Re: ARC-22-123 (ZON-22-078)
231 Bradley Place
Engineering Comments

231 BRADLEY PLACE
PREPARED FOR
ALKEON CAPITAL MANAGEMENT, LLC
TOWN OF PALM BEACH

231 BRADLEY PLACE
PREPARED FOR
ALKEON CAPITAL MANAGEMENT, LLC
TOWN OF PALM BEACH
SHEET NUMBER
C-200

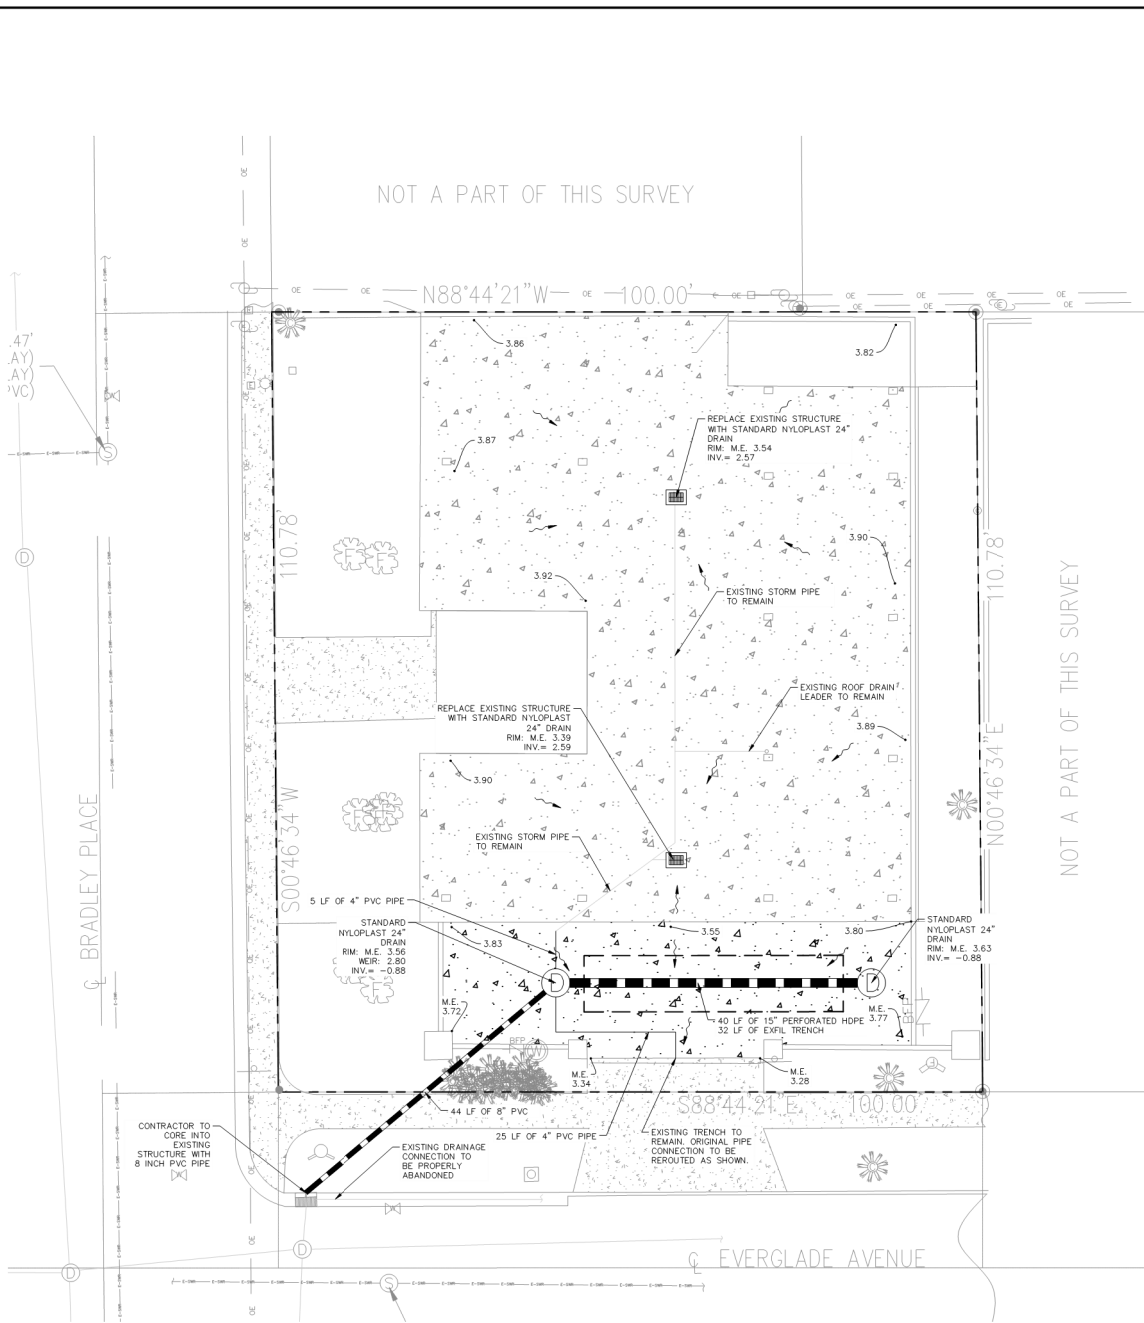
- 1. Recertification of existing stormwater management system. Paving and Grading plans meeting current standards need to be submitted. This can be accomplished with existing, installation of a new system to current standards, or a combination of the two.*

We have reviewed the existing stormwater system and offsite permit that the subject site drains to. The offsite system takes on flow from the basins listed in said permit. The subject site is located within one of these stormwater basins and is thus captured in the offsite system and ultimately discharged into the intercoastal waterway via an existing master stormwater pump station located adjacent the intercoastal waterway.

The subject site has existing area drains within the parking area and an existing trench drain along the south property line located on grade within the wall opening to the parking area. These drains take on stormwater flow from the parking area and roof drains, prior to discharging to the offsite system. The existing system does not appear to have any onsite retention.

We recommend the system be cleaned and recertified to meet the existing expectations of the system. The existing drainage plan has been created based on the survey information we received and is limited to show the discovered underground piping connections and the final grading of the new paver system that is designed by others. The existing system will be cleaned as needed so that the system may be recertified to meet the intent of the original design.
